CITY OF SALEM, MASSACHUSETTS

**Commercial Marina**  
**SALEM PORT EXPANSION PROJECT**  
**BLANEY STREET, SALEM, MA**  
**BID #R-44**

**ADDENDUM NO. 2**

January 27, 2016

EXHIBIT 1

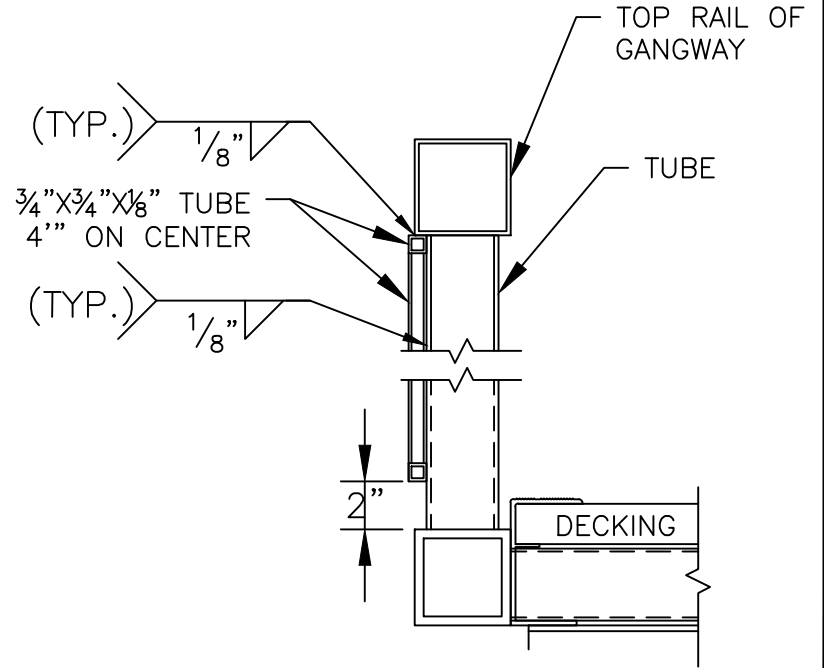
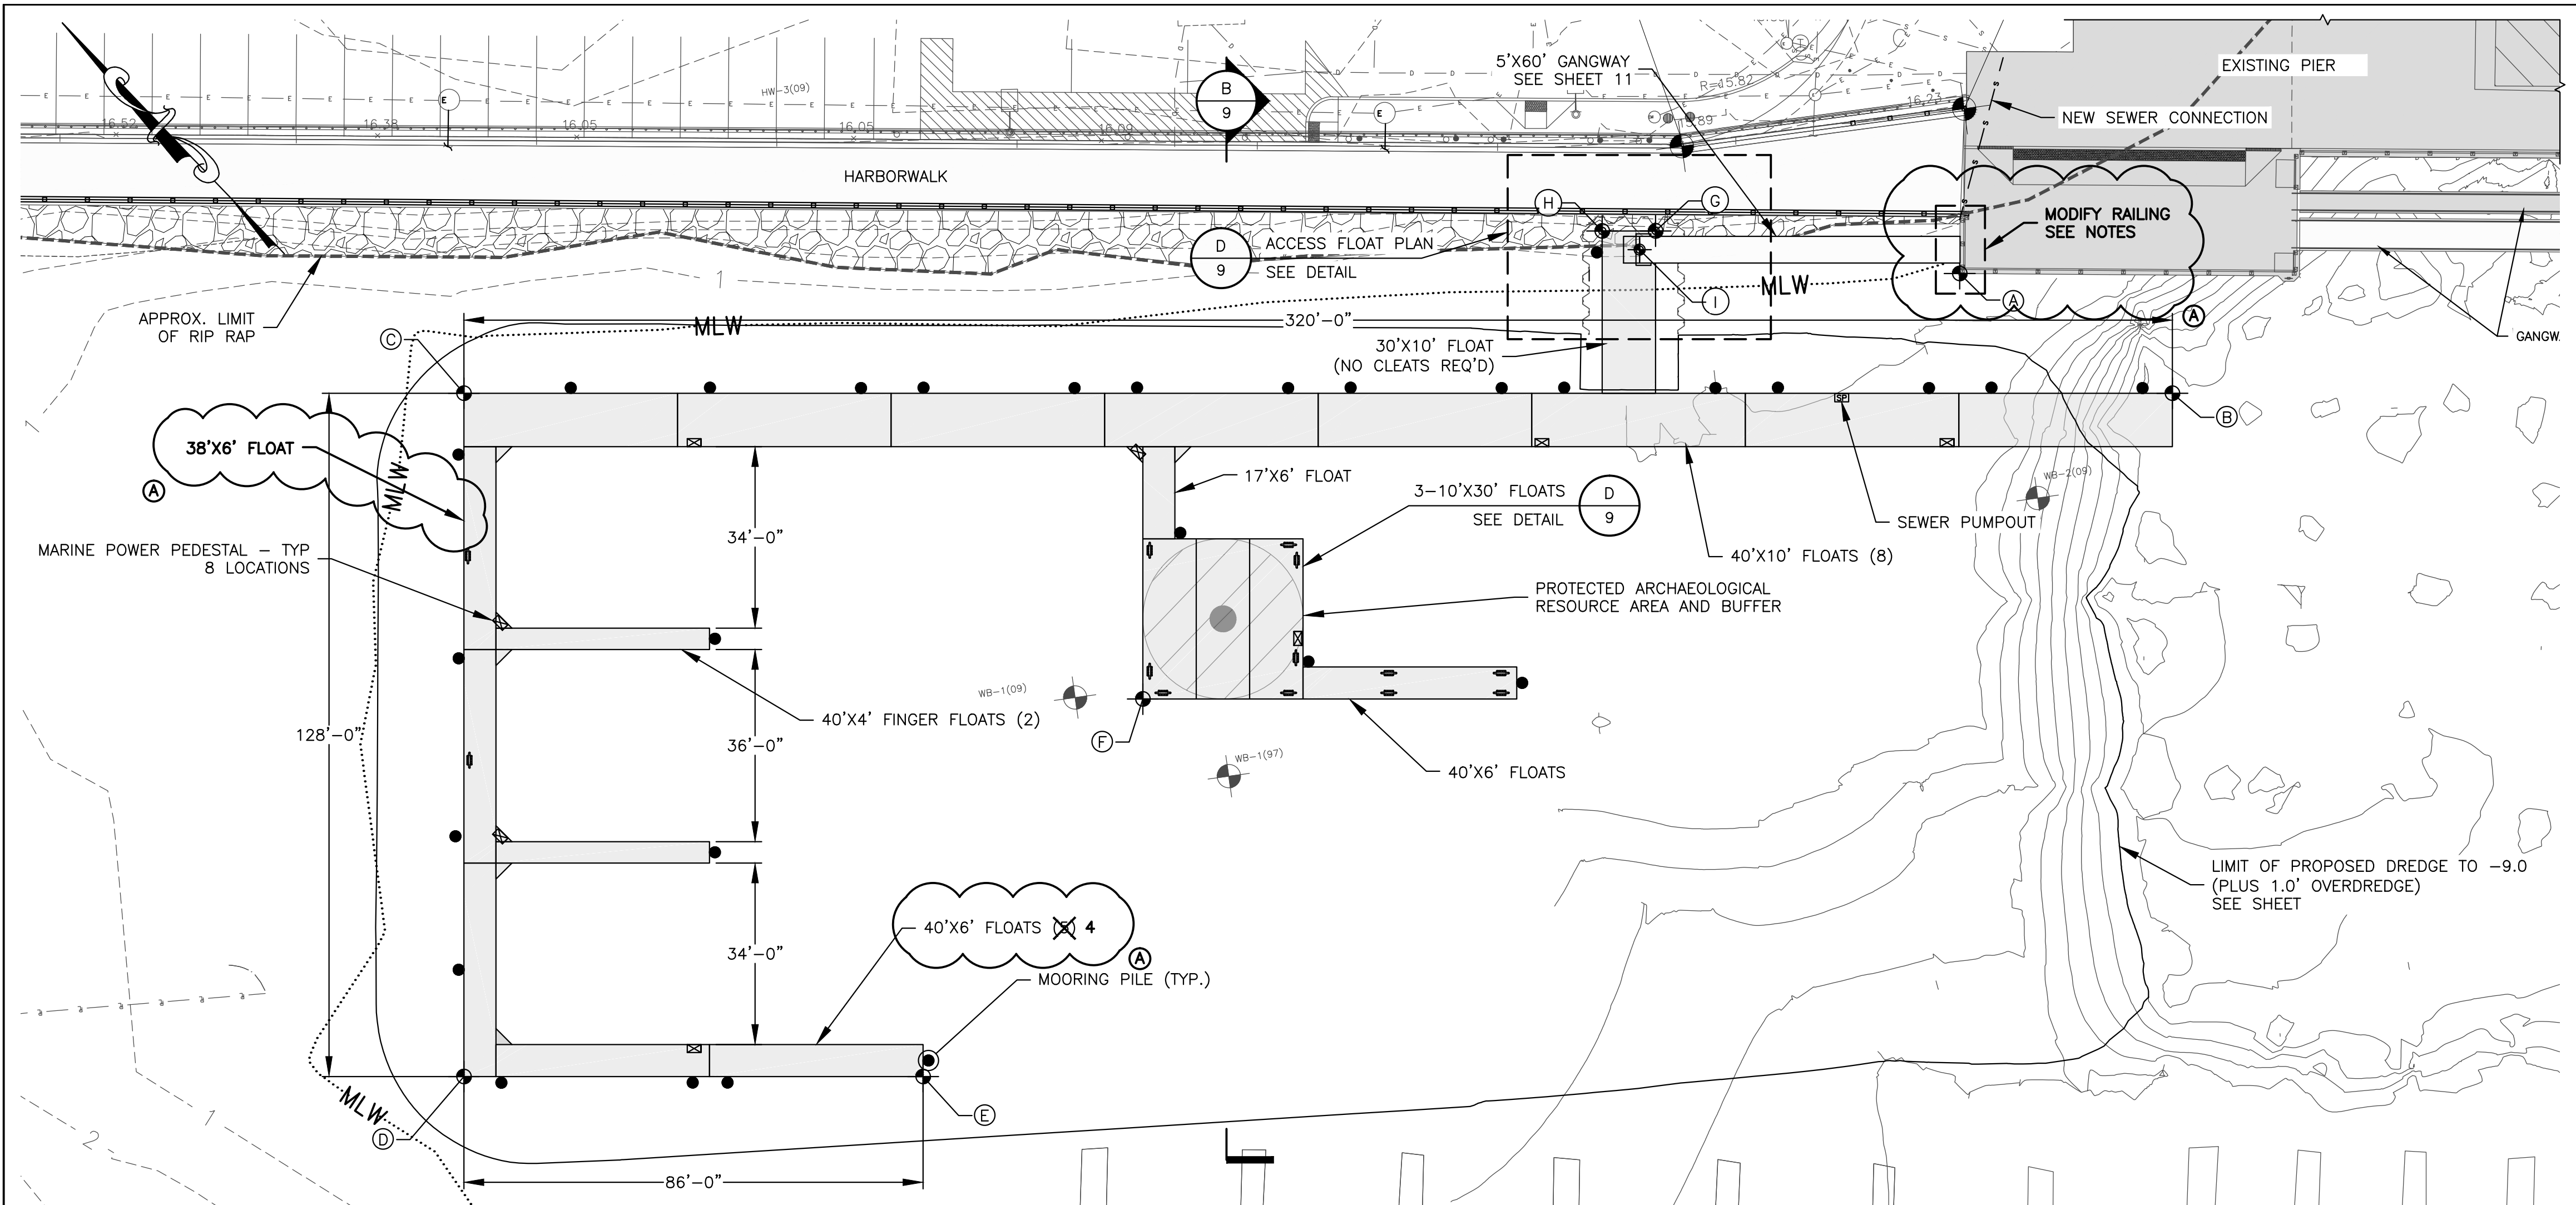
**DELETE Detail H/10  
INSERT Detail H/10 Exhibit 1 - ADDENDUM NO. 2**

**INSERT Detail H/11 Exhibit 1 - ADDENDUM NO. 2**

**ADDENDUM #2**  
**MARINA LAYOUT PLAN**  
COMMERCIAL MARINA  
SALEM PORT EXPANSION PROJECT  
CITY OF SALEM  
SALEM, MA  
DECEMBER 2015

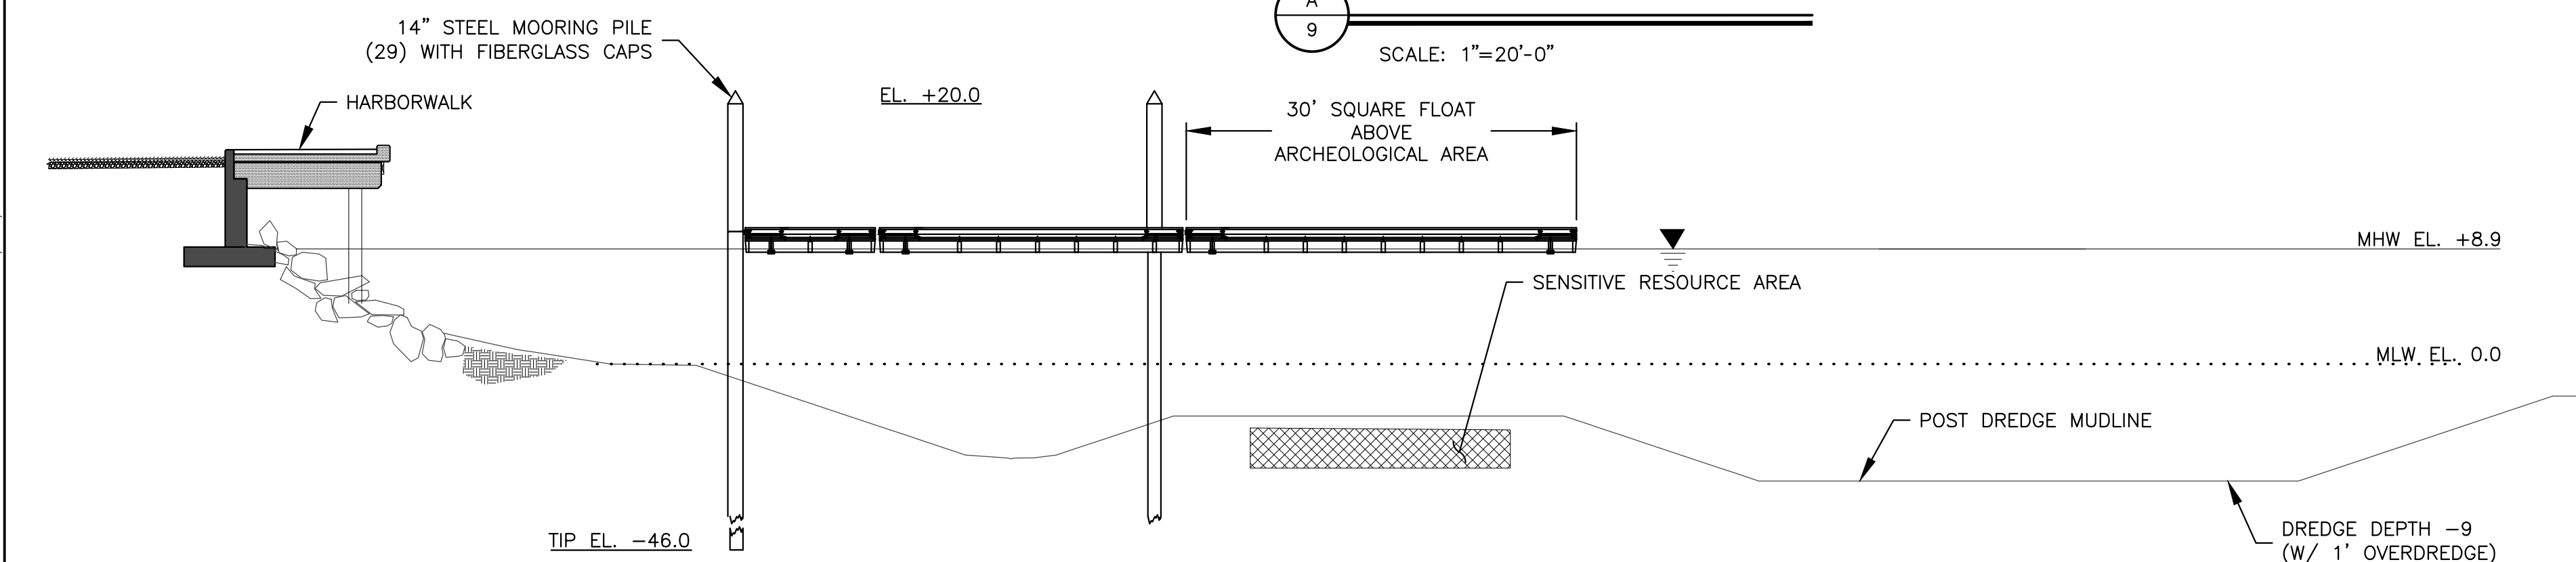
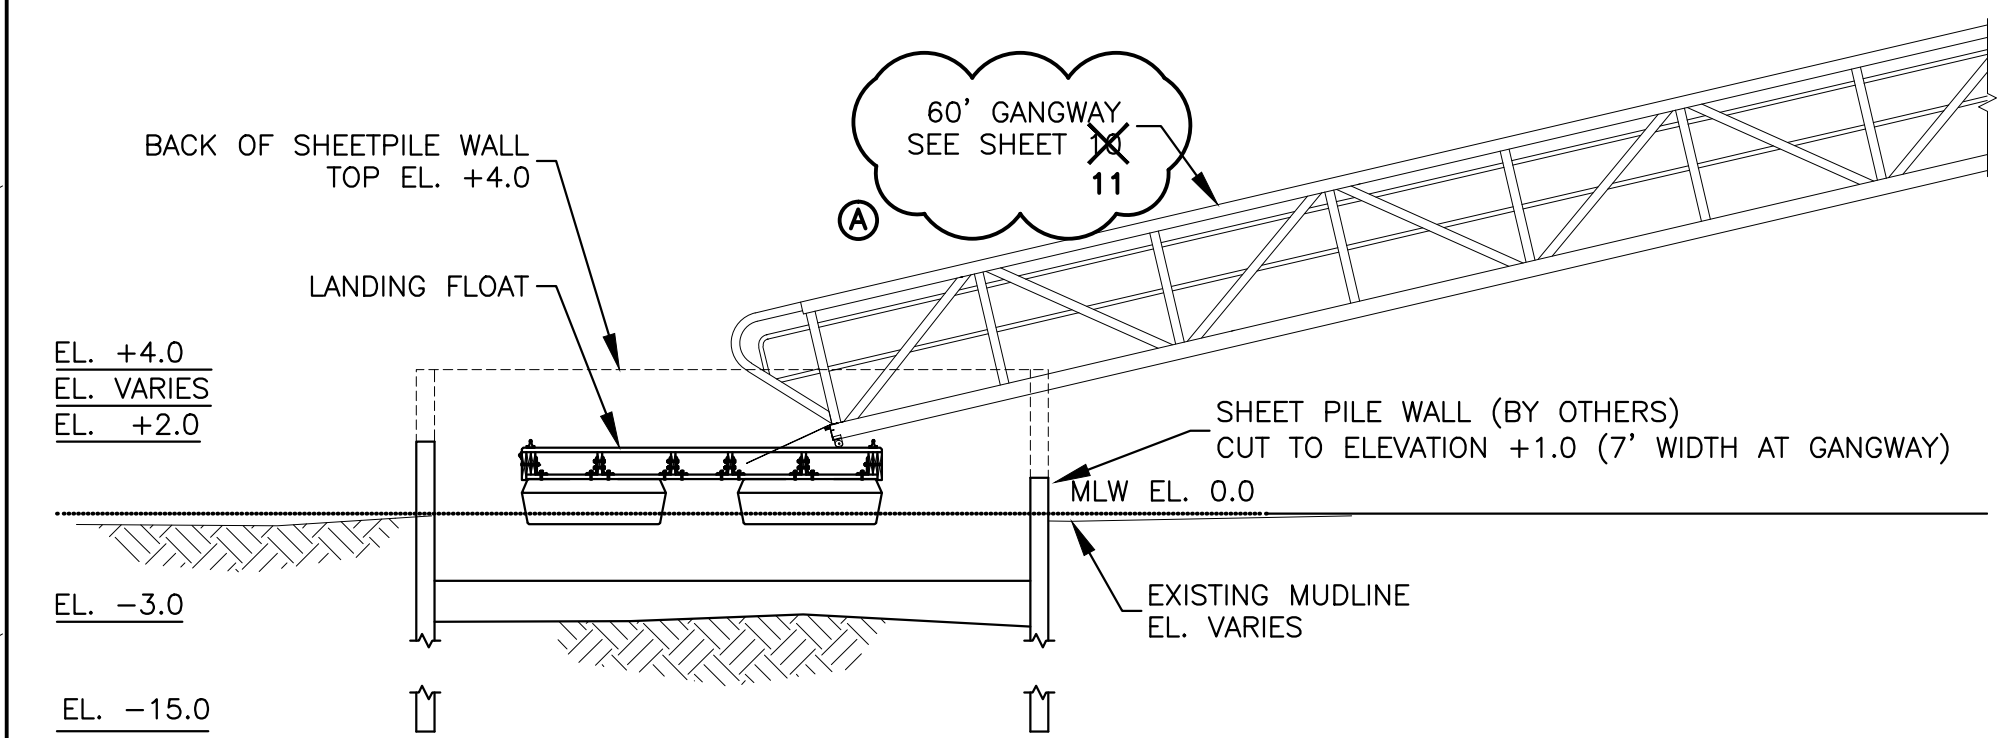
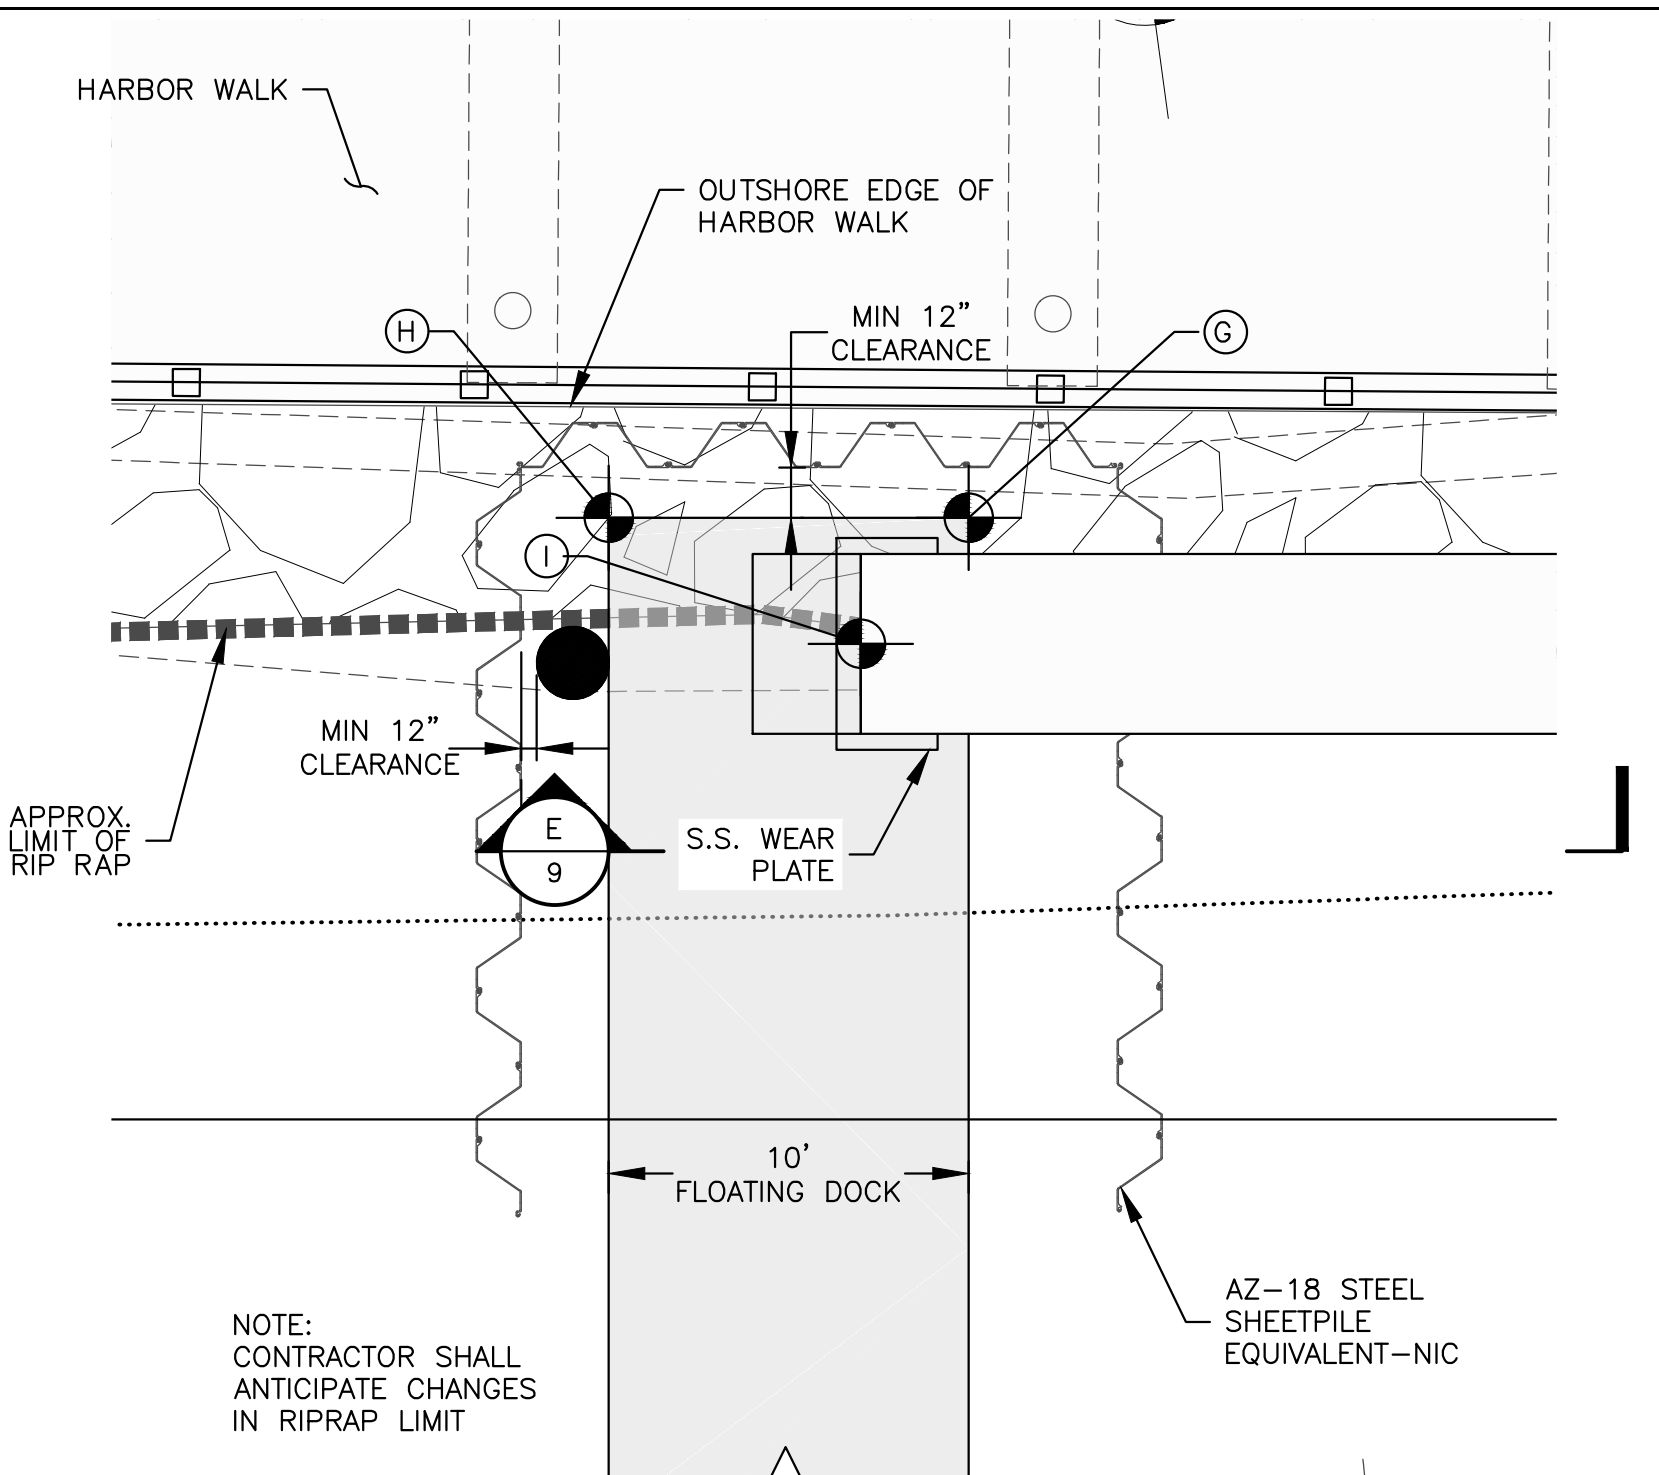
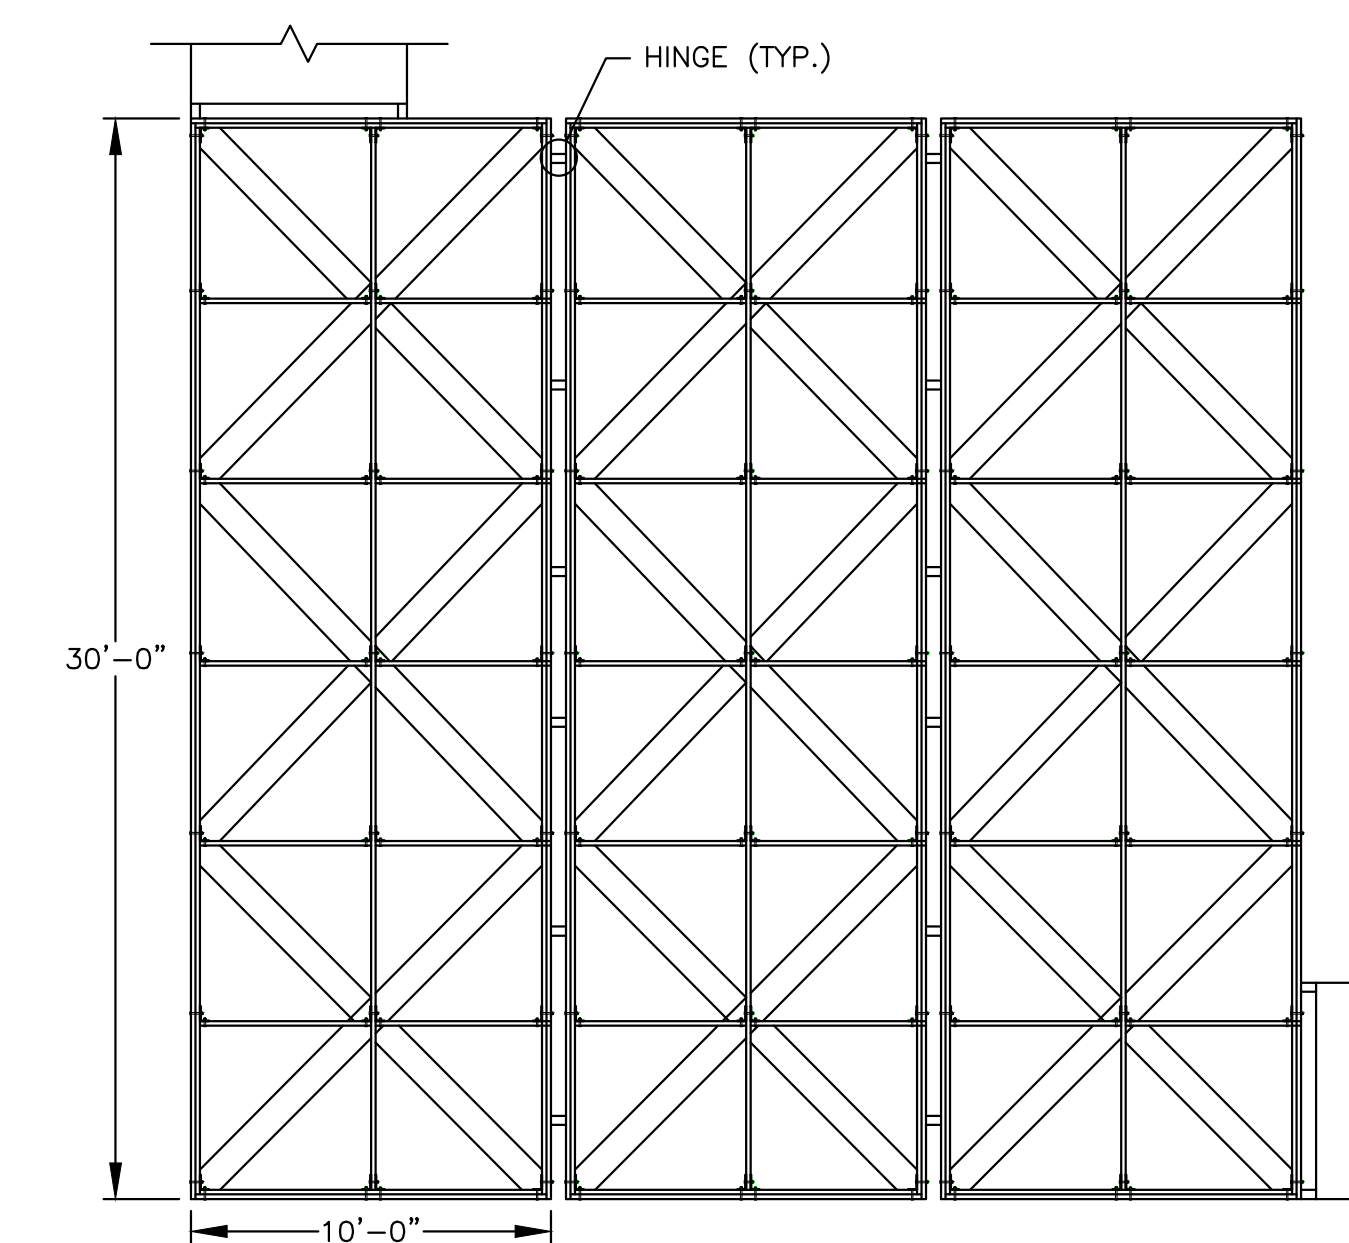
- e. The dimension across the inshore length does not match spacing with float widths? Should the end float be wider to match the total length?  
*Meeting response – We will review the float layout and provide an answer*

- q. Drawing 34005-02-11 – Sheet 9 of 13 The spacing on the 4x40 finger floats and the 6x80 finger floats totals 118’ where the mainwalks are shown as (3) 6x40 which total 120’. What is the correct dimension in this area?

- r. Drawing 34005-02-11 – Sheet 9 of 13 shows gusseted corners, because you will be installing power pedestals on the corners we would recommend they be at least 2’x2’ gussets. Please confirm size of gusseted corners.

**DELETE SHEET 9  
REPLACE WITH SHEET 9ADDENDUM NO. 2 – Modifications to float dimensions.**

**Final Response - All the float sizes should match the widths and lengths shown on Sheet 9 of the Contract Drawings. Total width across the inshore end should be 128'-0". See the attached Sheet 9 Addendum No . 2**

***The correct dimension is 118'-0" as shown on sheet 9 – see attached revised sheet 9 addendum No.1***

***The gusseted corners shall be 3’x3’.***
